HISTORIC AND DESIGN REVIEW COMMISSION

HDRC CASE NO: 2022-527

ADDRESS: 108 SCHREINER PLACE

TYPE OF WORK: Construction of a carport

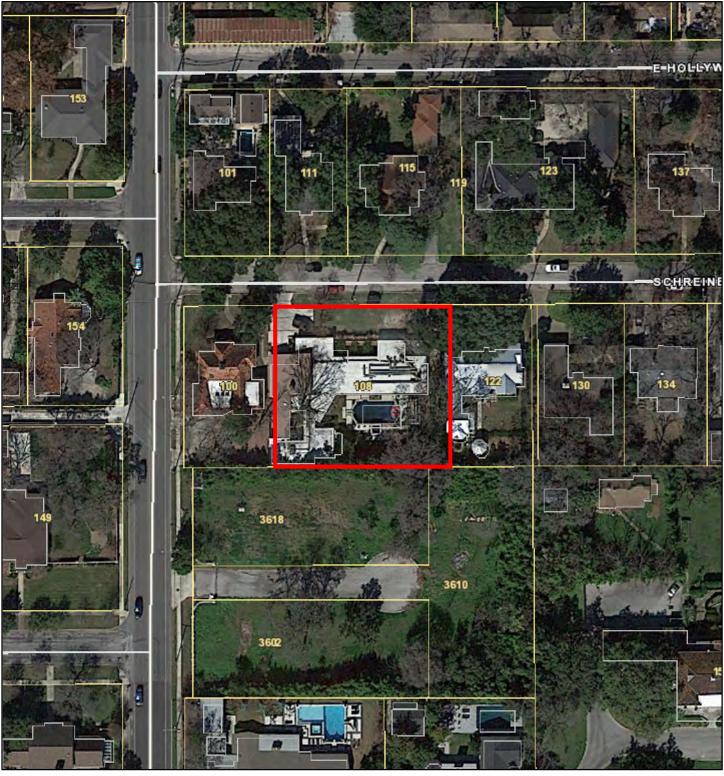
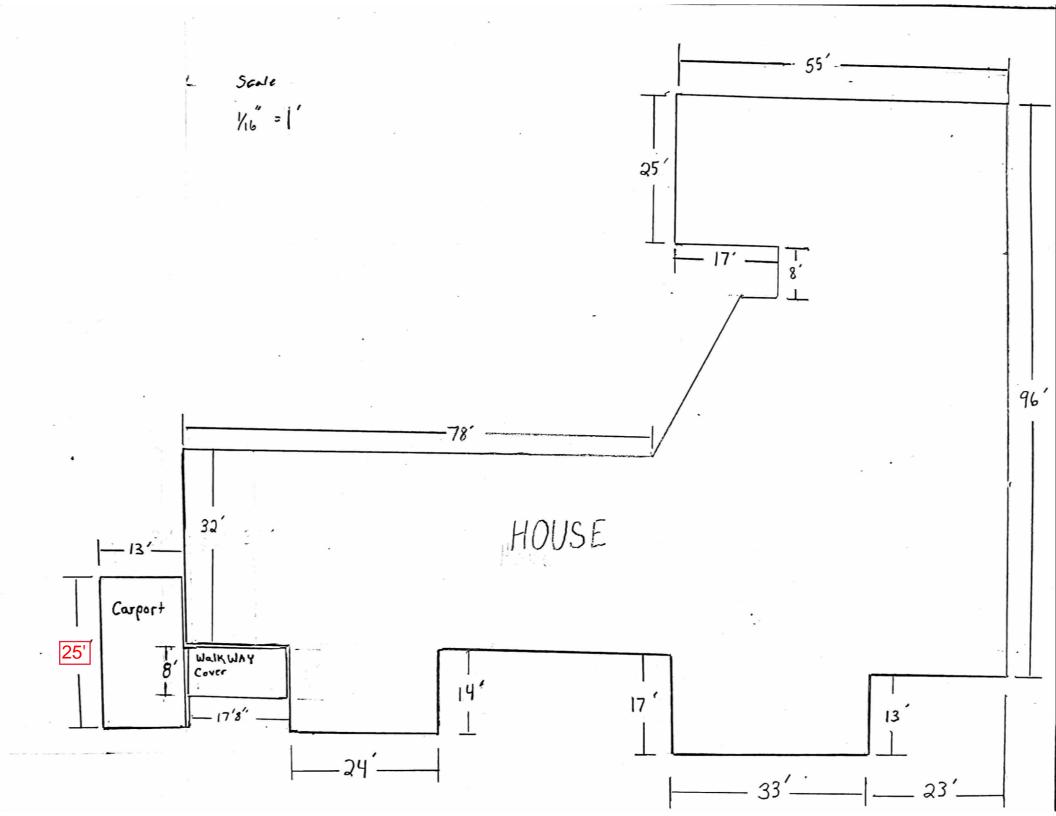
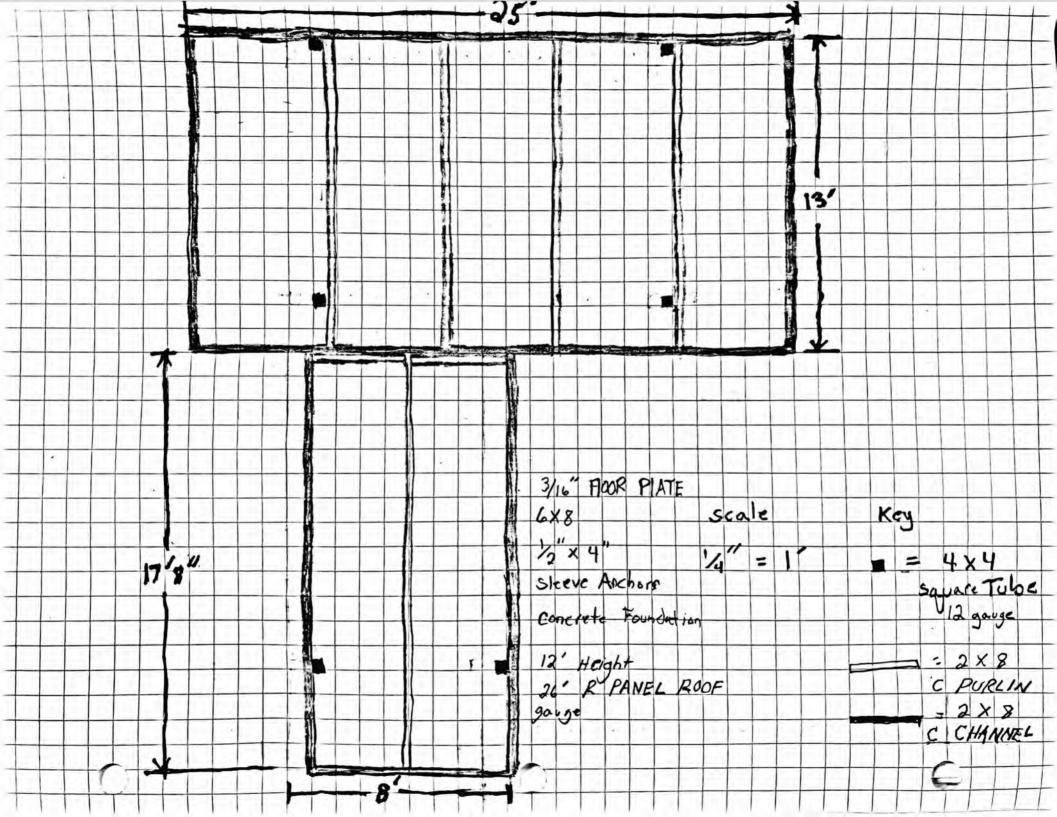
- b. VIOLATION: On September 28, 2022, OHP staff learned through a citizen report that a detached metal-framed carport was constructed without a Certificate of Appropriateness. Staff posted a Notice of Investigation and Stop Work Notice on site the same day. The report is included in this case file.

- c. CARPORT (MASSING AND FORM): The applicant installed a detached metal-framed carport with a flat R-panel metal roof on the east side of the property. Though it is detached, the carport is taller than the primary flat roof form and overlaps the east edge of the roof. Historic Design Guidelines for Additions 5.A.i states that new garages and outbuildings should be designed to be visually subordinate to the principal historic structure in terms of their height, massing, and form. Staff finds the carport does not conform to guidelines.

- d. CARPORT (MATERIALS): The applicant installed a detached metal-framed carport with a flat R-panel metal roof on the east side of the property. Historic Design Guidelines for Additions 5.A.iii states additions should relate to the period of construction of the principal building on the lot through the use of complementary materials and simplified architectural details. The primary structure on the lot is clad in brick and horizontal wood siding, and the shed roof is clad in standing-seam metal. The use of metal is consistent with the architectural style of the home and conforms to guidelines.

Staff recommends approval to construct a carport based on findings d and e, with the following stipulation:

i. That the applicant proposes a carport with a roof form subordinate to that of the primary structure, specifically one that is shorter than the primary roof.
